Determination 2017/042

Regarding compliance of building work with Clause E1 of the Building Code at 1–5 Saint Bathans Lane, Papanui, Christchurch

Summary

Figure 1: site location and topography (from expert's report) (not to scale)

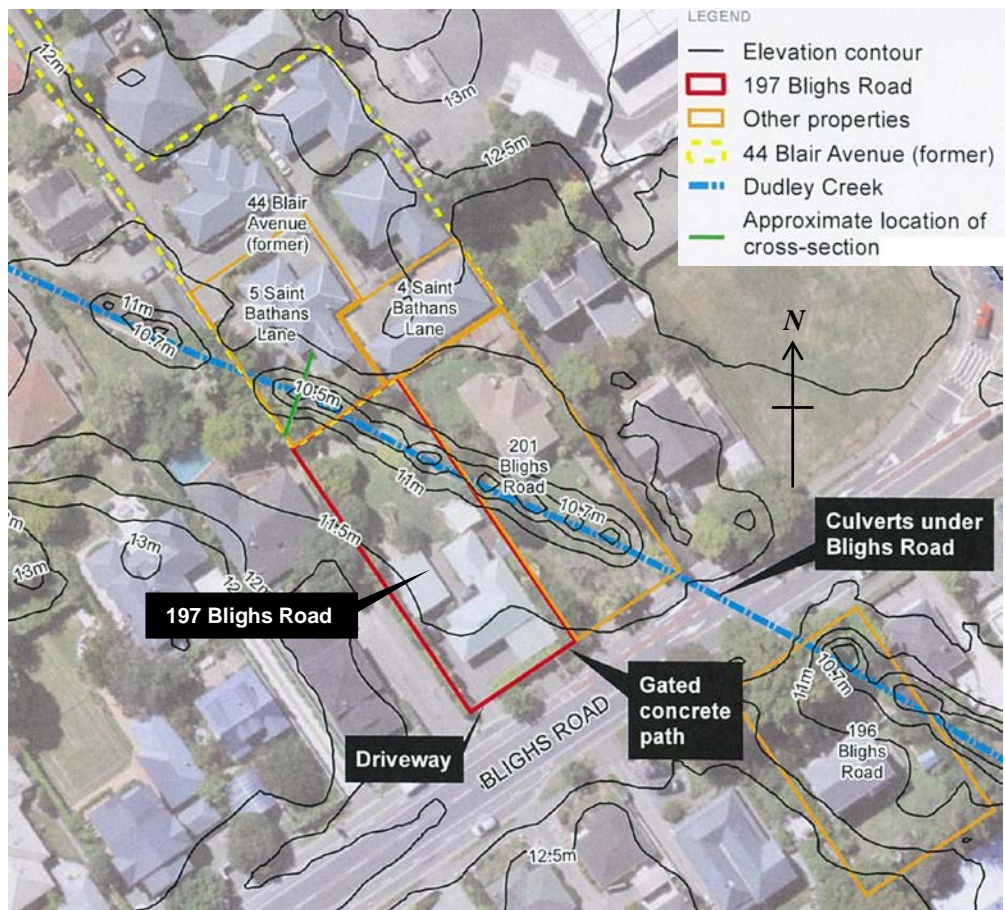
- 2.1 The applicant’s property is situated in an urban area in central Christchurch. The property is relatively flat, with a gradual slope from its street frontage on Blighs Road on its south-east side, down toward its northern corner. Dudley Creek crosses this northern corner at an angle, running from a north-western to a south-eastern direction.

- 2.2 Before it enters the applicant’s property, the creek crosses the corner of the property directly behind the applicant’s (5 Saint Bathans Lane). It enters the applicant’s property under the rear boundary fence, and leaves under the boundary fence with 201 Blighs Road. The boundary fence at both locations where the creek goes under is a standard 1.8m high timber paling fence. After leaving the applicant’s property the creek crosses the adjacent property at 201 Blighs Road. It then enters a concrete arch culvert, which takes the creek under Blighs Road.

- 2.3 Blighs Road is a two-lane city street, with standard road kerb and flat drainage channels on both sides. Between the road and the boundary of the applicant’s property, there are planted gardens and a footpath. The footpath has another drainage channel set within it. The footpath channel drains to a corner sump in the footpath outside 201 Blighs Road, which itself drains into the under-road culvert. The road channel drains into a double sump set into the road outside 201 Blighs Road, which also leads to the culvert.

- 2.4 The levels of Blighs Road and its footpath are both slightly higher than the ground level of the applicant's property, and there is very little fall between the applicant's driveway and either the road kerb and channel or the footpath channel. The driveway leads to the house and garage, which are the main buildings on the applicant's property. The rear of the property is lawns and gardens, which the creek dissects.
- 2.5 The building work that is the subject of this determination ("the development") took place on the properties to the rear of the applicant's property at what was formerly 44 Blair Avenue and subsequently renamed 1–5 Saint Bathans Lane. The building work replaced two existing flats, garages and sheds on the property with five townhouses.
